Planning and Zoning Meeting

Monday, June 12, 2017

City of Westlake
Planning and Zoning Department
Staff Report – 6/5/2017

REQUEST: Amend the Westlake TTD Design Standards to reflect updated Context Sensitive Community Identification Monuments, updated Residential Pod Entry signs, updated Directional signs, and to add Non-Residential Pod Entry signs and residential Gate Totems.

CONTEXT SENSITIVE COMMUNITY IDENTIFICATION MONUMENTS

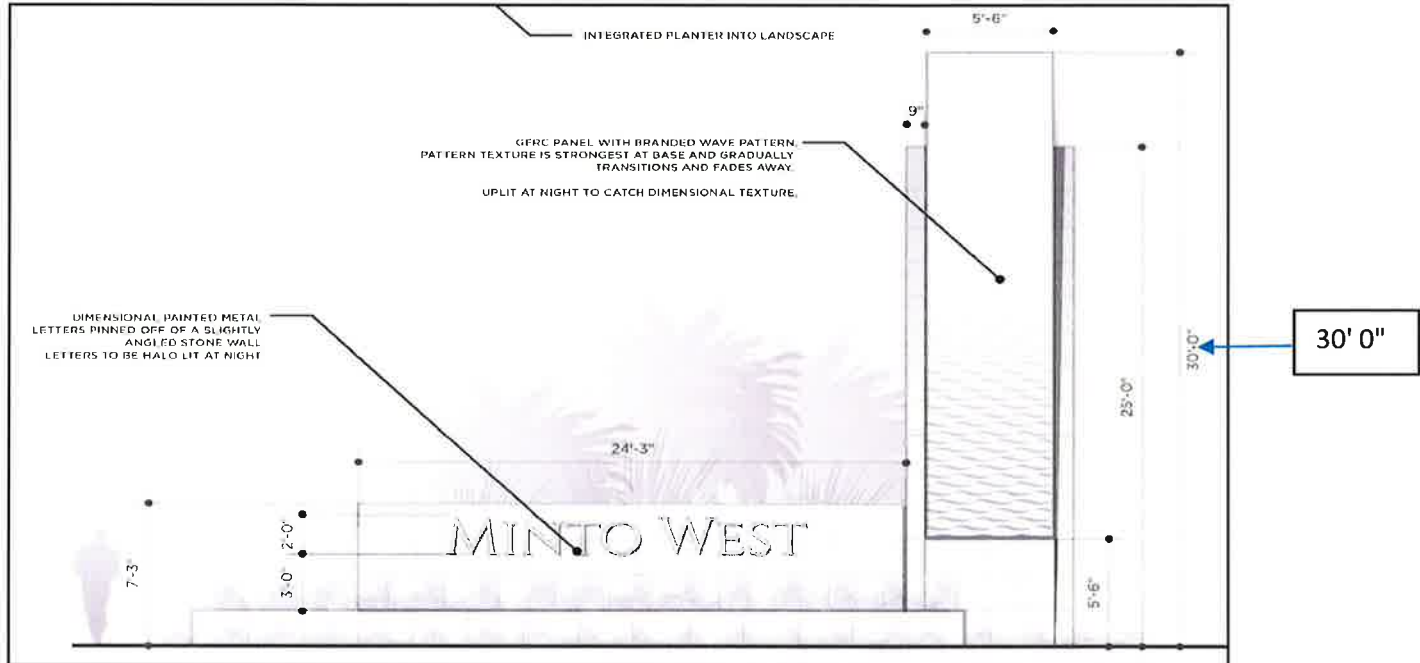
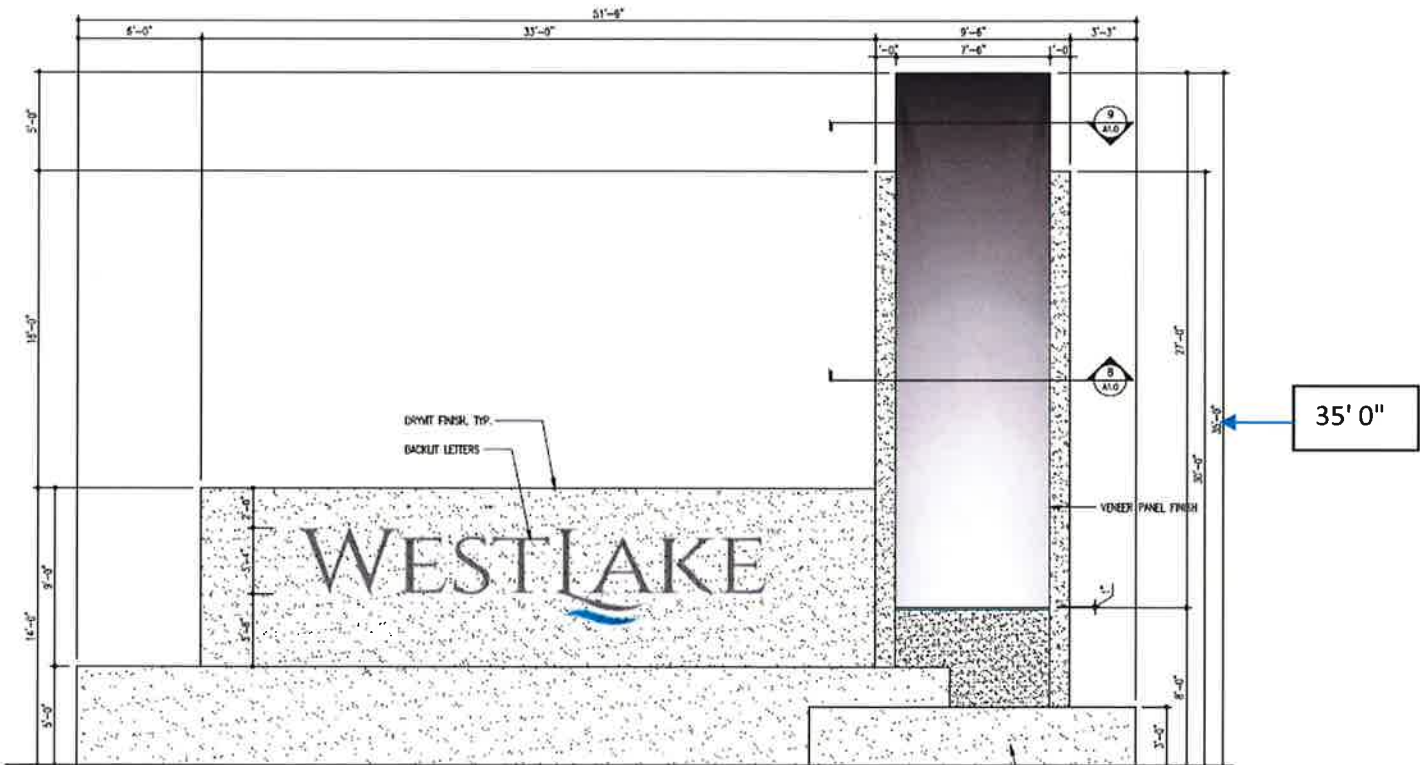
The monument features initially shown in the TTD Design Standards document were 30 feet high by 40 feet long (390 SF overall). The proposed monuments are approximately 35 feet high by 52 feet long (824 SF overall). According to the Applicant, the overall size of the monuments was increased to ensure the proper scale was achieved.

MEASUREMENTS	APPROVED MONUMENTS	PROPOSED MONUMENT	PERCENTAGE OF CHANGE
HEIGHT	30 ft.	35 ft.	+ 16%
WIDTH	40 ft.	52ft.	+ 30%
OVERALL SF	390 SF	824 SF	+111%

NON-RESIDENTIAL POD ENTRY MONUMENT SIGN

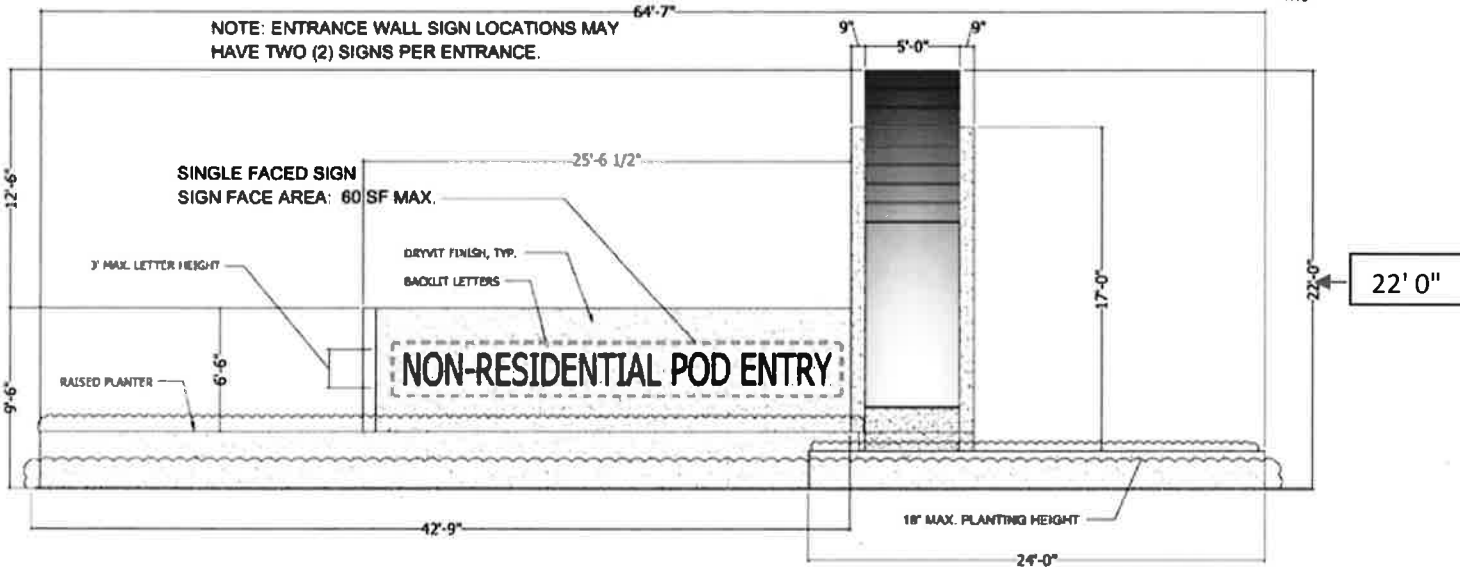
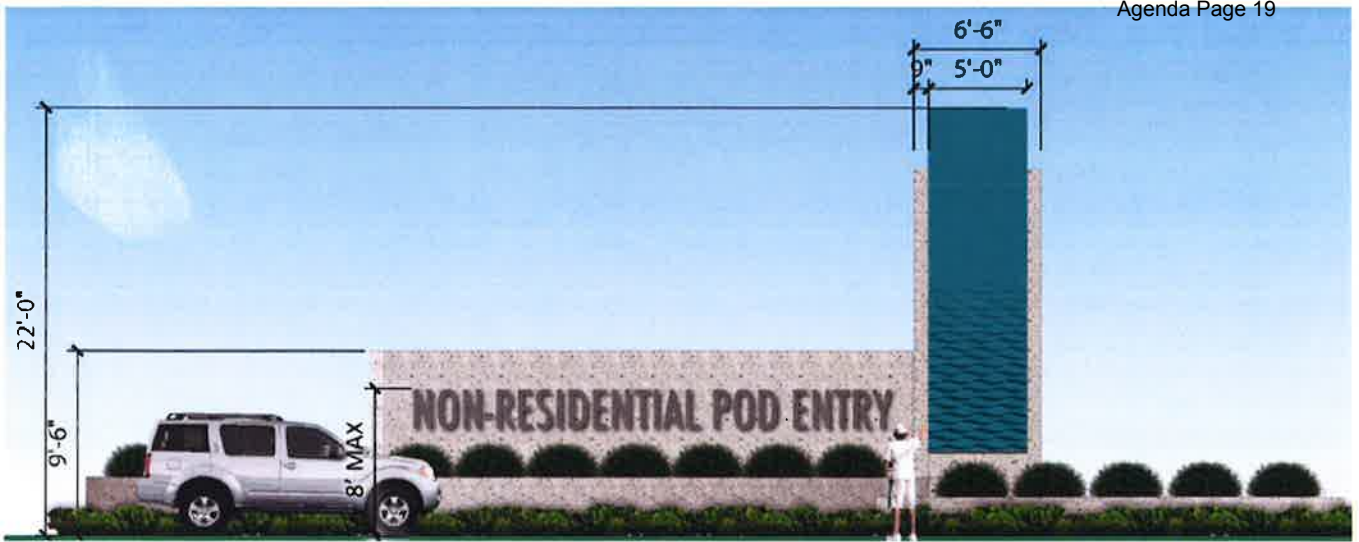
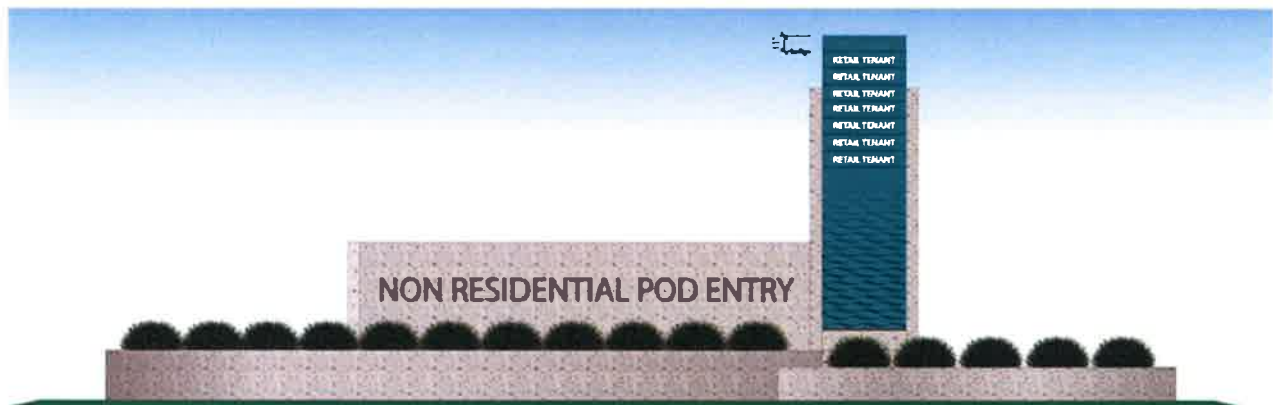
The newly proposed Non-Residential Pod Entry monument sign is larger than its Residential Pod counterpart, and includes an area on the totem element for tenant identification names. The addition of tenant names is inconsistent with Table 8.G.2.C - Entrance Sign Standards cited above, in that sign copy and graphics are limited to the name and address of the development, cannot exceed 60 sq. ft. of sign face, or exceed a maximum 8-foot sign height. The Applicant has submitted a request for a concurrent ULDC text amendment to address these discrepancies.

Staff recommends that the tenant identification names be uniform in font and color, the maximum letter height be 10.5 inches, and the tenant identification name area be no higher than 21 feet. *An amendment to Article 8 of the ULDC will be required to accommodate the addition of tenant identification names on the Non-Residential Pod Entry signs. Staff also recommends that a uniform sign plan specifying material, fonts, colors, sign type [hanging, cabinet, projecting, etc.] and location be required for each non-residential development.*

Finally, an amendment to Article 8 of the ULDC will be required to accommodate the addition of tenant identification names on the Non-Residential Pod Entry signs. Staff also recommends that a uniform sign plan specifying fonts, colors, sign type [hanging, cabinet, projecting, etc.] and location be required for each non-residential development at the time a site plan review is submitted.

DIRECTIONAL SIGNS

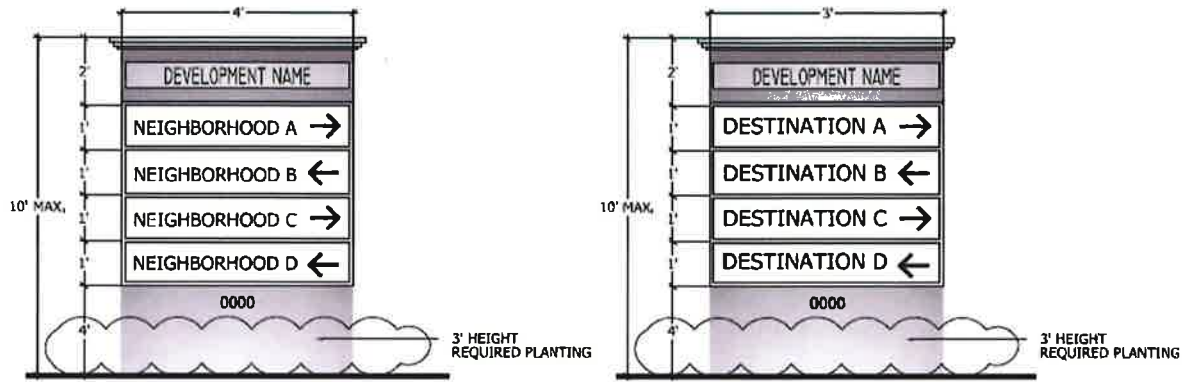
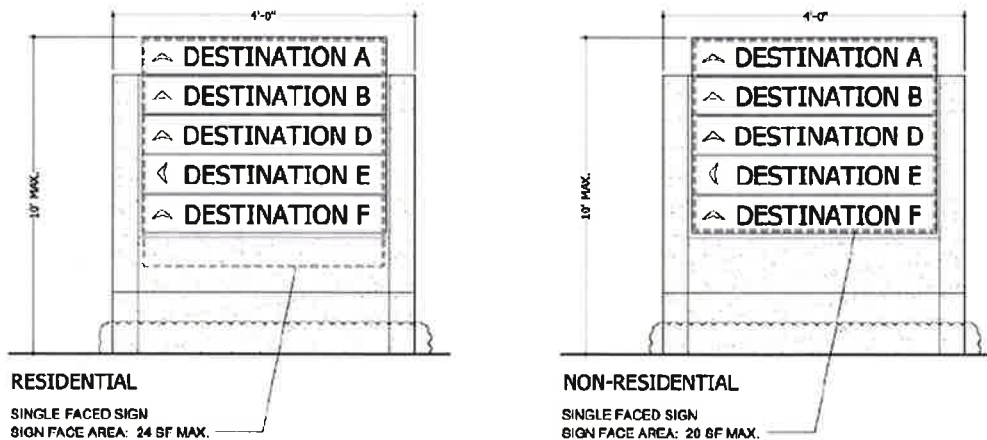
The Applicant proposes to modify the design of the approved Directional signs “to reflect the theming and design of the Westlake community.” The minimum and maximum dimensions of the proposed Directional signs will remain the same. The approved and proposed Directional signage is illustrated below.

RESIDENTIAL GATE TOTEM

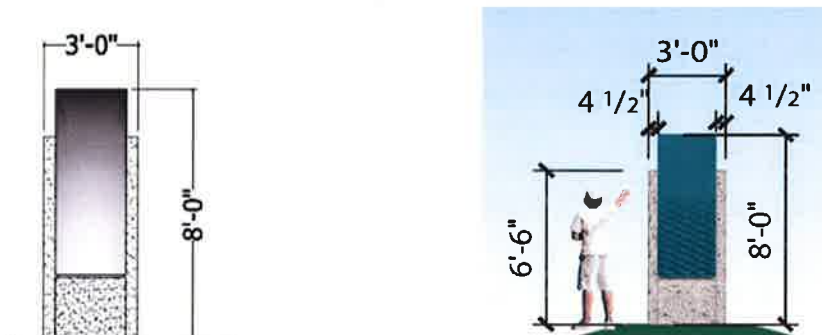
A residential Gate Totem is proposed to be added to the Design Standards for Pod Q to be used as entry gates. With regard to entry gates, the ULDC Article 3.F.2.c.(2) indicates "The use of gates or other preventative barriers shall not be permitted on collector streets." Also, on the Development Order conditions of approval under Planning-General. Condition #46 To ensure that the "appropriate new urbanism concepts" provision of the Agricultural Enclave statute is fulfilled, no Traditional Neighborhood Pod shall be gated or otherwise have restricted access. The Gate Totems are in compliance with above regulations since they are not proposed to be located on a collector street and are not to be included on a Traditional Neighborhood Pod.
